# SERVICE LETTER

No. 195

Piper Aircraft Corporation

Subject: Battery Cable and Rudder Cable Interference

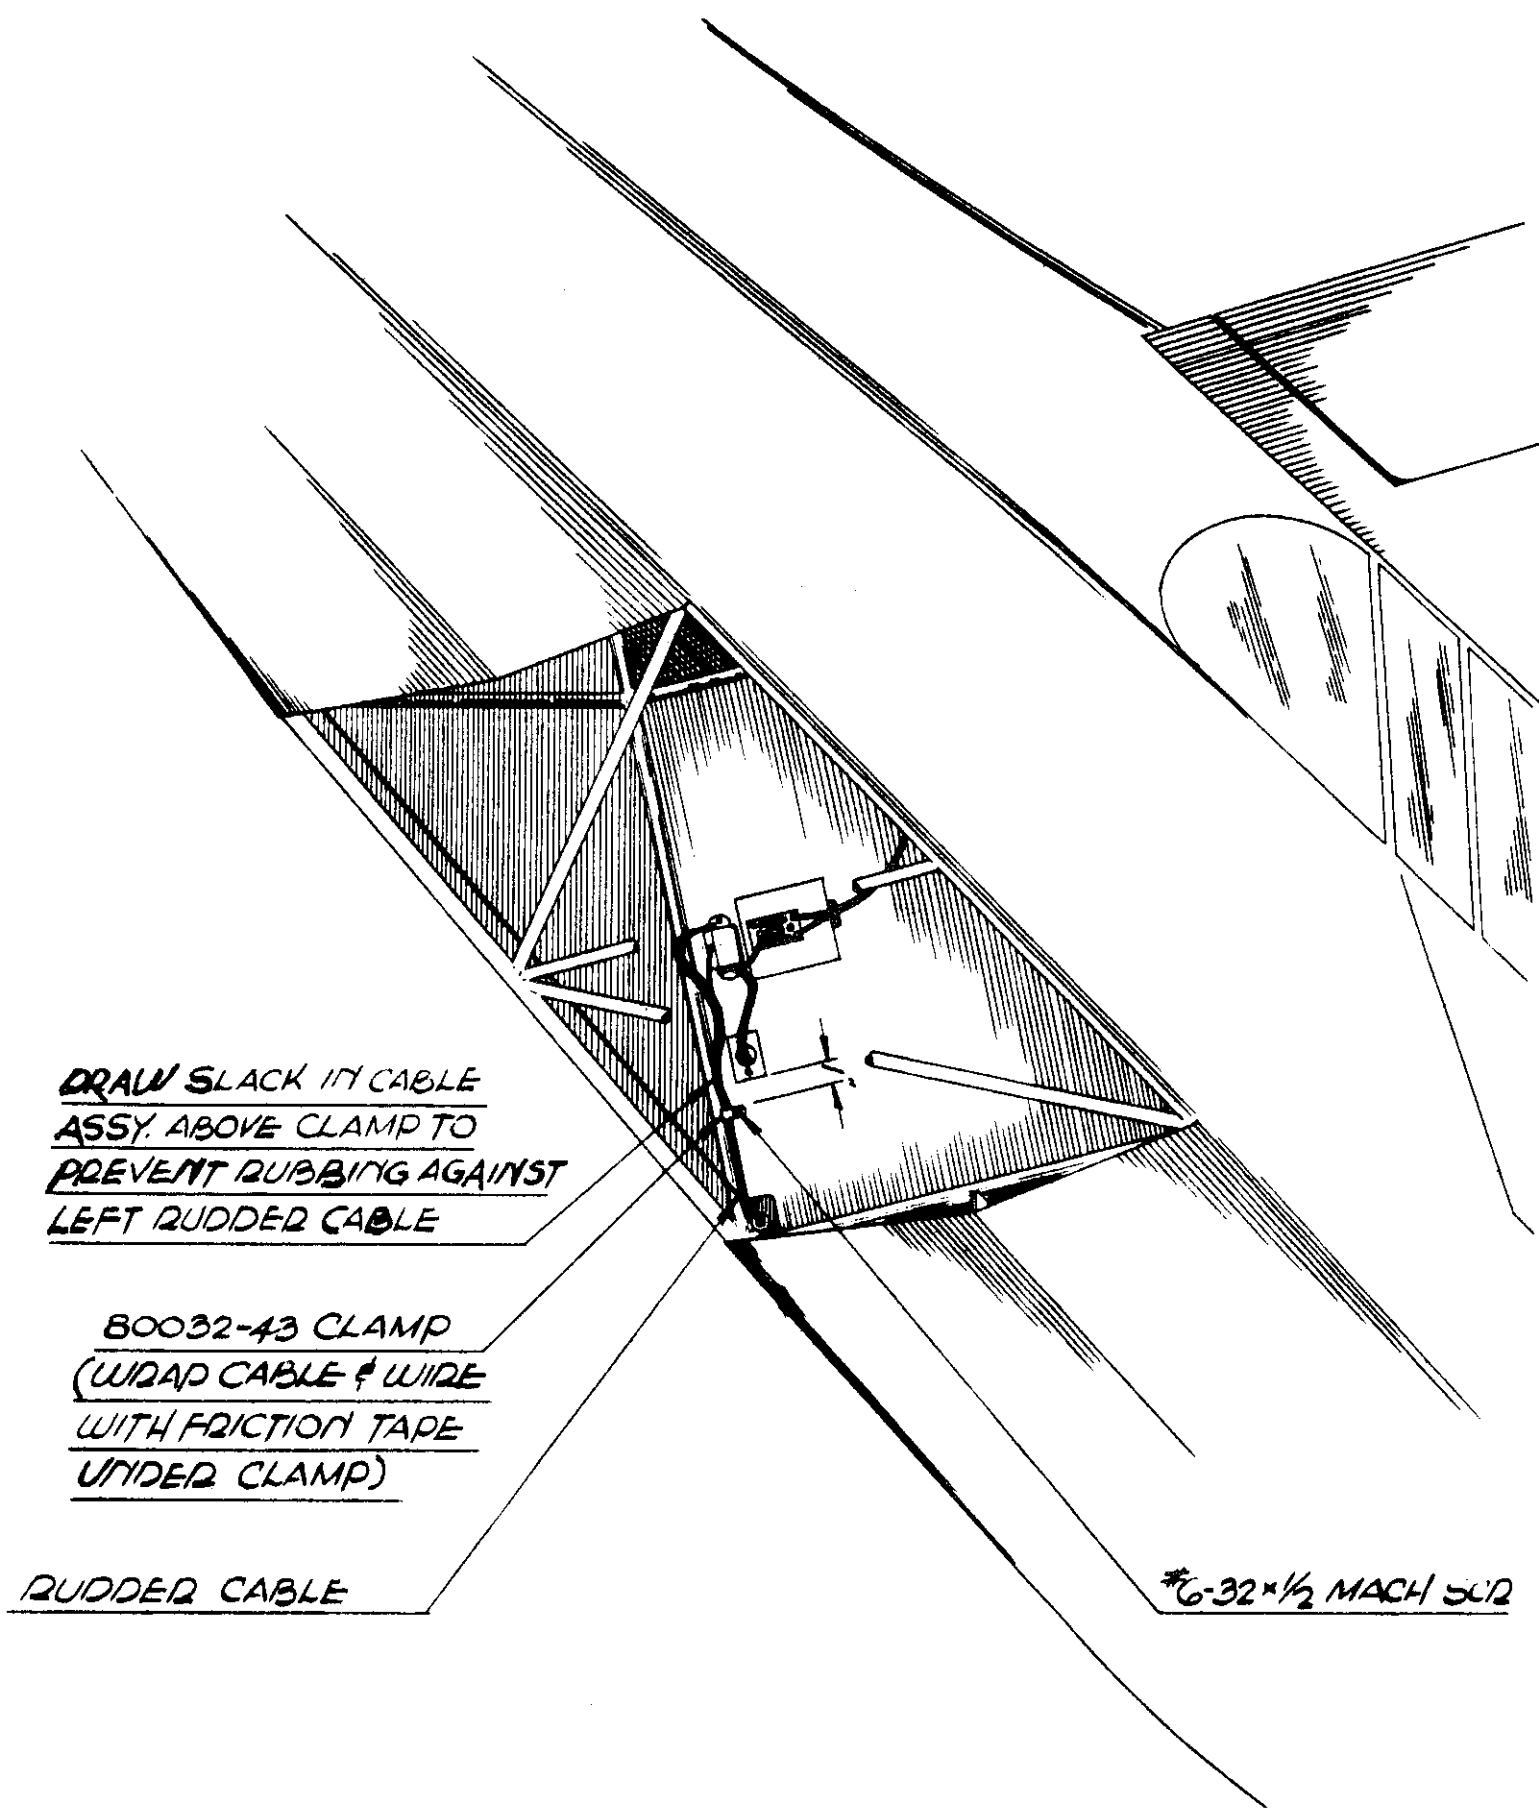
We have found there is a possibility of interference between the battery cable and the left rudder cable, back of the baggage compartment panel on the PA-18A Agricultural Airplane.

The method of installing the battery cable has been changed at the Factory and it is recommended that all PA-18A Airplanes in the field be inspected to determine whether or not there is interference and in any case, use the following procedure to correct the installation.

1. Remove the center belly panel.
2. Wrap the battery cable and solenoid wire together with friction tape, shellac, and install one (1) clamp, part number 80032-43, around the taped area and fasten it to the baggage compartment panel with a 6-32 x 1/2" machine screw, as per the attached sketch. Make certain that all of the slack is drawn out of the battery cable to prevent its rubbing the rudder cable.
3. Replace the belly plate.

DRAW SLACK IN CABLE  
ASSY. ABOVE CLAMP TO  
PREVENT RUBBING AGAINST  
LEFT RUDDER CABLE

80032-43 CLAMP  
(W/AD CABLE & WIRE  
WITH FRICTION TAPE  
UNDER CLAMP)
